MCNEIL FAMILY SUBDIVISION

Engineering Comments: FINAL PLAT COMMENTS (should be addressed prior to submitting the FINAL PLAT for review and/or signature by the City Engineer):

APPLICATION NUMBER 4 DATE July 6, 2017

DETAIL SITE PLAN

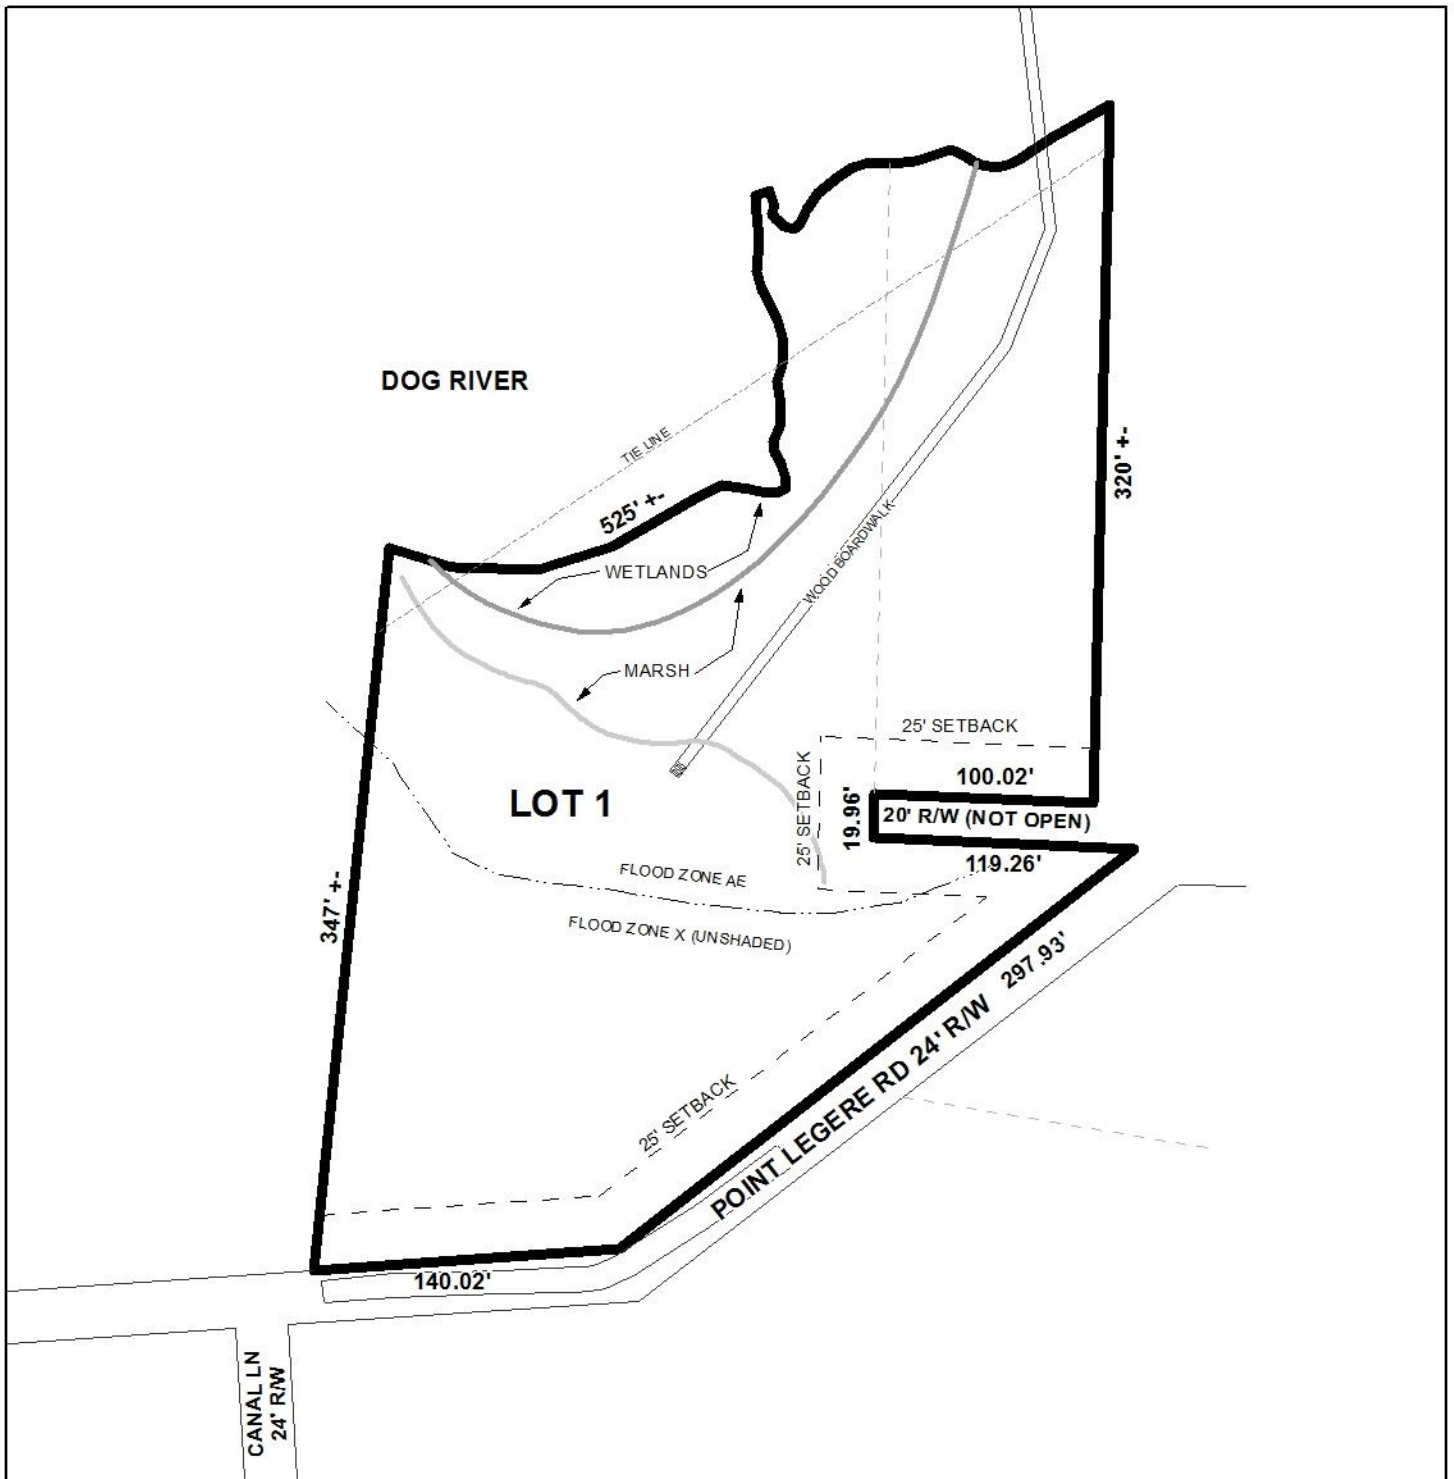
The proposed lot has frontage on Point Legere Road, a minor street without curb and gutter requiring a 60' right-of-way width. The preliminary plat illustrates a 24' right-of-way, but right-of-way dedication has been required for other Subdivisions along Point Legere Road, including for a 2009 Subdivision across the street from the subject site. As such, the plat should be revised to illustrate dedication 30' from the centerline of Point Legere Road.

It should be noted that the site also has frontage on an unimproved, unopen proposed minor street referred to as Evergreen Lane. 20' of right-of-way is illustrated and should be revised to dedicate 60' for future improvements; or, the applicant could consider submitting a request to have the right-of-way vacated.

The corner radii at the intersection of Point Legere Road and the unimproved, unopen proposed minor street should be dedicated per Section V.D.6. of the Subdivision Regulations should the applicant not request vacation.

As a means of access management, a note should be required on the Final Plat stating the lot is limited to two curb cuts to Point Legere Road with any changes in their sizes, locations or designs to be approved by Traffic Engineering and conform to AASHTO standards.

The preliminary plat illustrates the 25' minimum building setback line along both existing and proposed street frontages. This information should be retained on the Final Plat, if approved, adjusted for any required dedication.

The lot is irregular in shape, as is common among proximal lots approved by the Planning Commission, but nevertheless meets the minimum size requirements of the Subdivision Regulations for lots served by public water and sanitary sewer systems, even after right-of-way dedication. Its size is appropriately labeled in square feet and acres on the preliminary plat and, if approved, should be retained on the Final Plat; or, provision of a table with the same information should suffice.

Finally, Dog River extends along the North portion of the site and wetlands associated with the river are illustrated on the preliminary plat. As such, the area may be environmentally sensitive; therefore, the approval of all applicable federal, state and local agencies would be required prior to the issuance of any permits or land disturbance activities.

- 1) revision of the plat to illustrate dedication 30' from the centerline of Point Legere Road;
- 2) revision of the plat to illustrate dedication 30' from the centerline of the proposed minor street, or submission of a request to vacate the right-of-way;

- 3) dedication of the corner radii at the intersection of Point Legere Road and the proposed minor street, or submission of a request to vacate the right-of-way;
